BROOKHAVEN NATIONAL LABORATORY
ASSOCIATED UNIVERSITIES, INC.

October 21, 1982

Re: Evaluation of Analytical Fire Modeling in Northern States Power Company's NSPFHA02, Final Report, June 30, 1982 "Fire Protection Safe Shutdown Analysis Compliance with 10 CFR Part 50, Appendix R, Section III.G and Substantive Basis for Exemption Requests", for Prairie Island Nuclear Generating Plant.

Figure 1. Scaled Heat Flux versus Scaled Forced Ventilation Rate

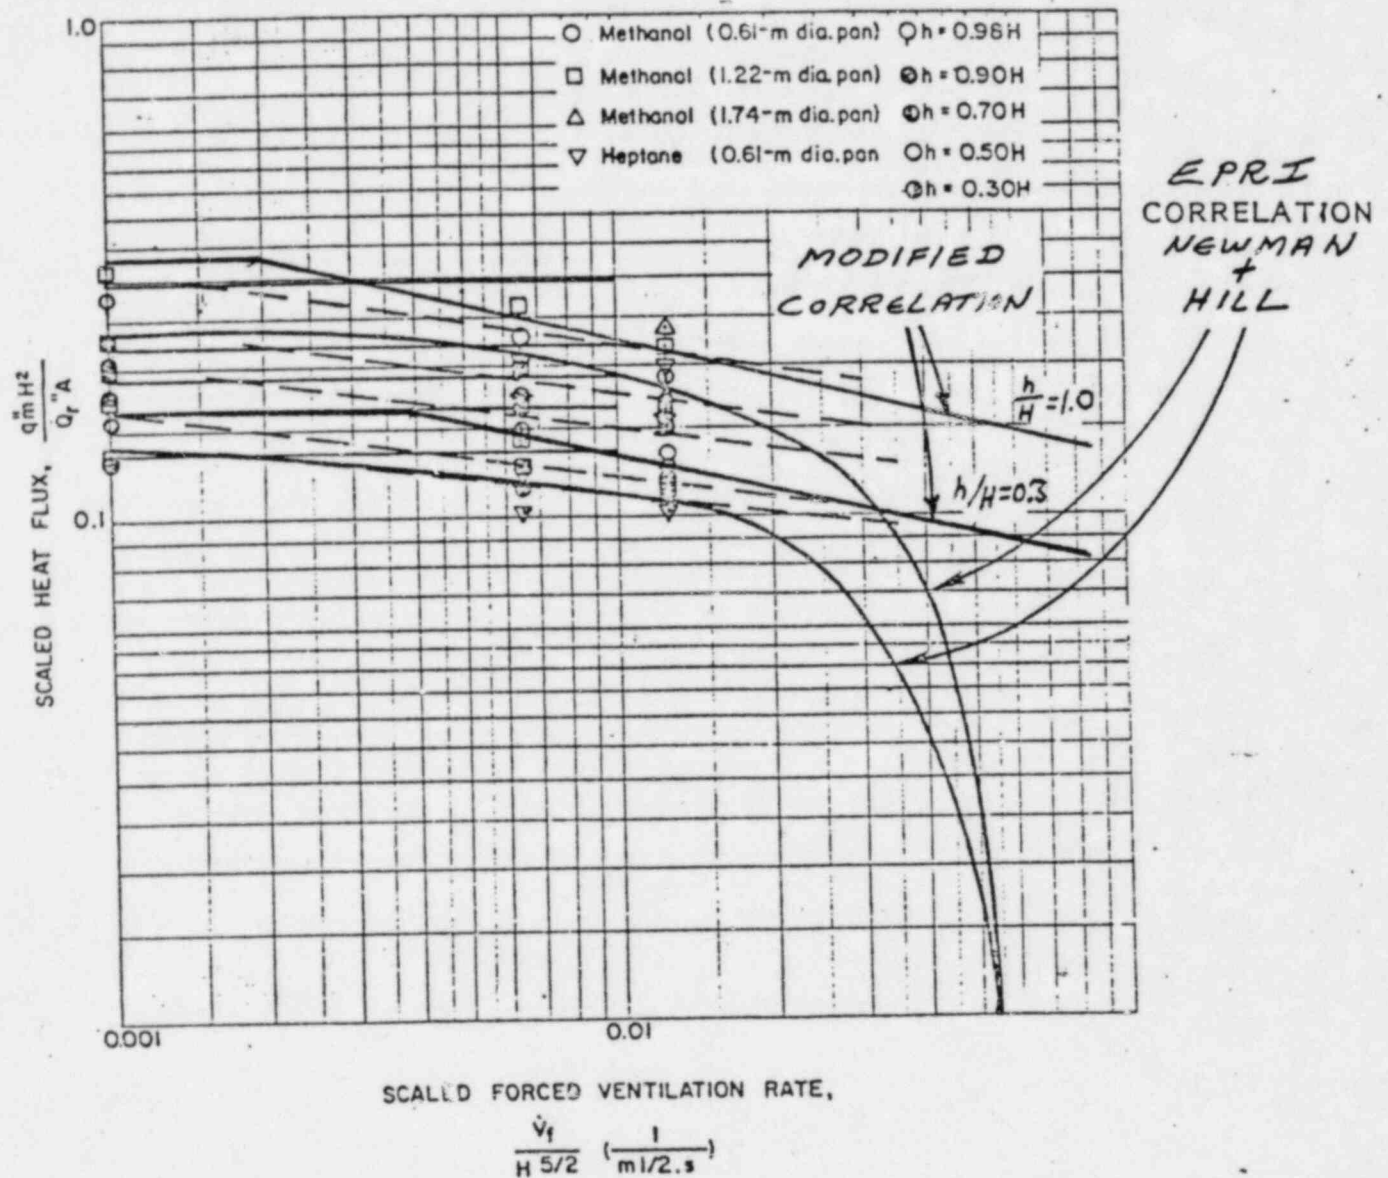
The submittal does not use the Newman and Hill correlation exactly as presented in reference 1. Instead a modified form as given on page A.2-4 is used. Apparently, this was done to extend the correlation at ventilation rates greater than those for which measurements were taken in reference 1. This fact, coupled with the unrealistic cooling behavior of the original Newman and Hill correlation at higher ventilation rates as shown in Figure A.2-2 leads to the need for the modified correlation, which continues the data trend to higher values of ventilation. This modified correlation is more conservative than the original. Since the labeling of Figure A.2-2 is somewhat confusing, it is replotted as Figure 1 (attached) with the modified correlation on page A.2-4 included.
